RE: OCONEE NUCLEAR STATION, UNIT NOS. 1, 2 & 3

3.17 FIRE PROTECTION AND DETECTION SYSTEMS

SAFETY EVALUATION BY THE OFFICE OF NUCLEAR REACTOR REGULATION

OCONEE NUCLEAR STATION, UNITS NO. 1, 2 AND 3

Figure 6.1-2

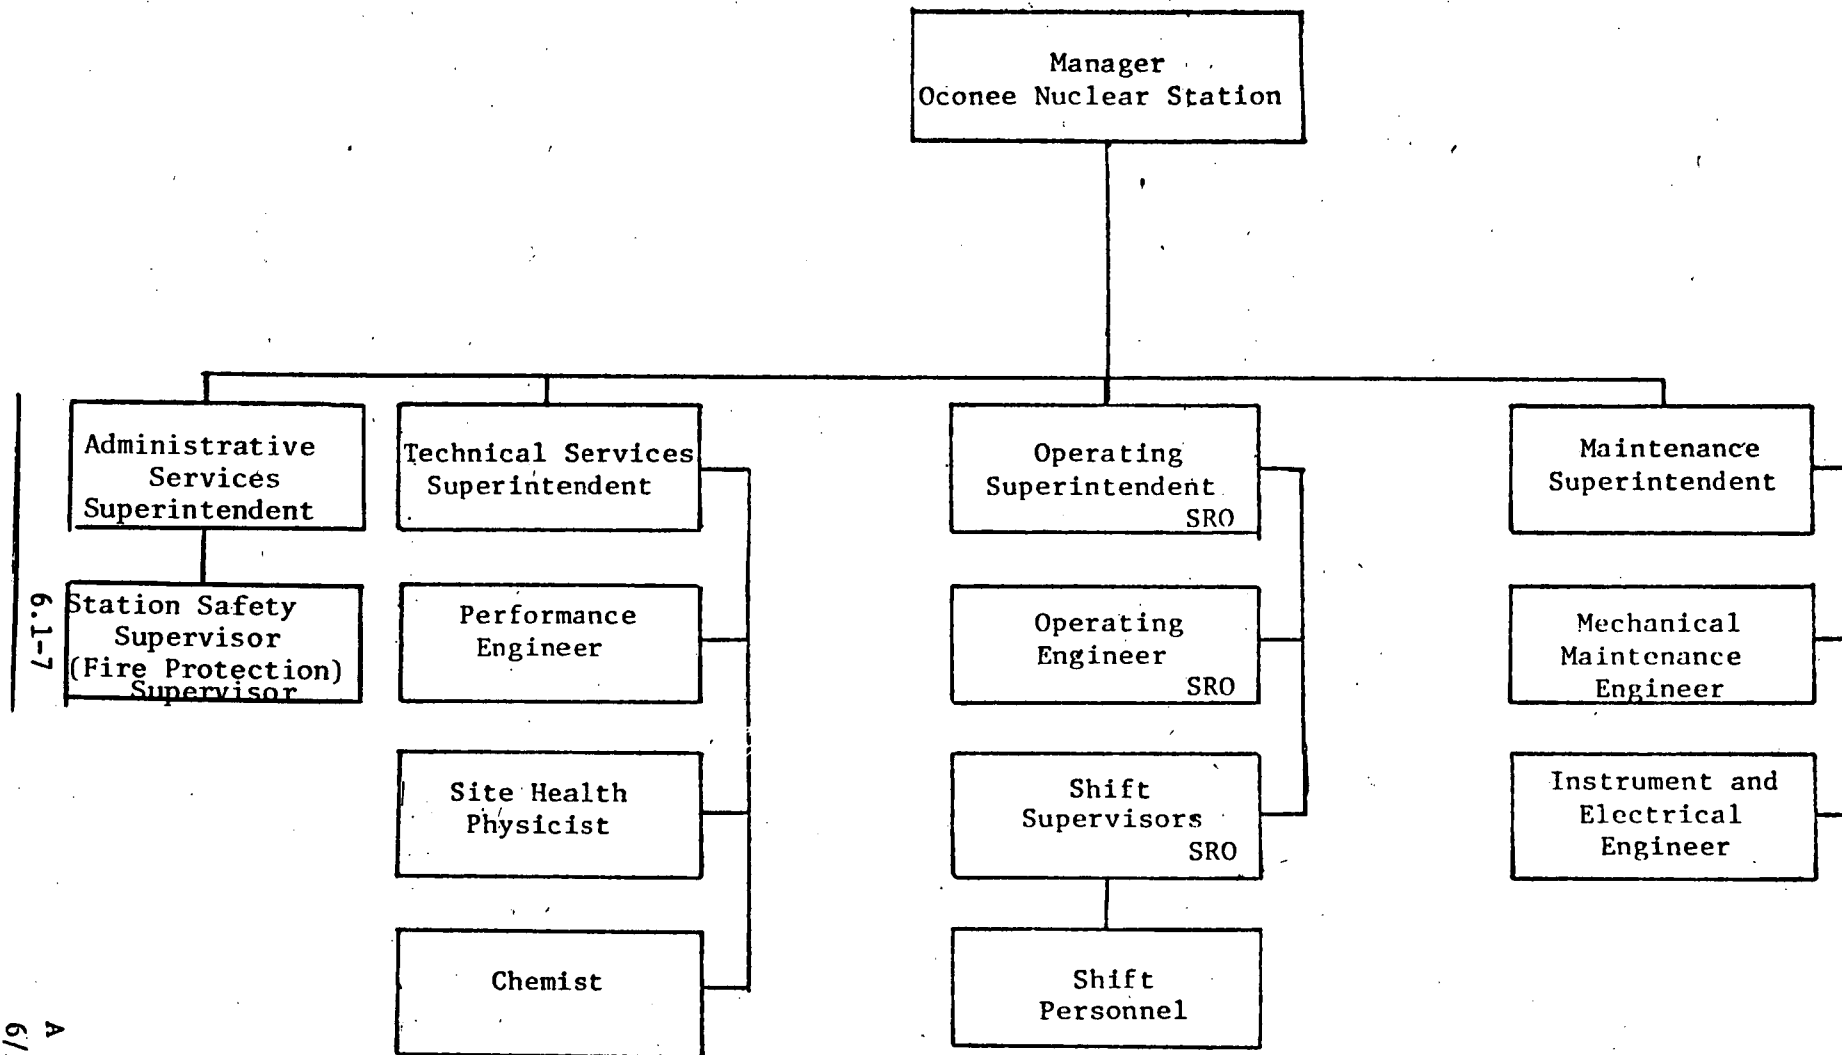
- 6.1.1.2 In all matters pertaining to actual operation and maintenance and to these Technical Specifications, the station Manager shall report to and be directly responsible to the Vice President, Steam Production, through the Manager, Nuclear Production. The organization is shown in Figure 6.1-2.

*Responsible for Fire Protection Program
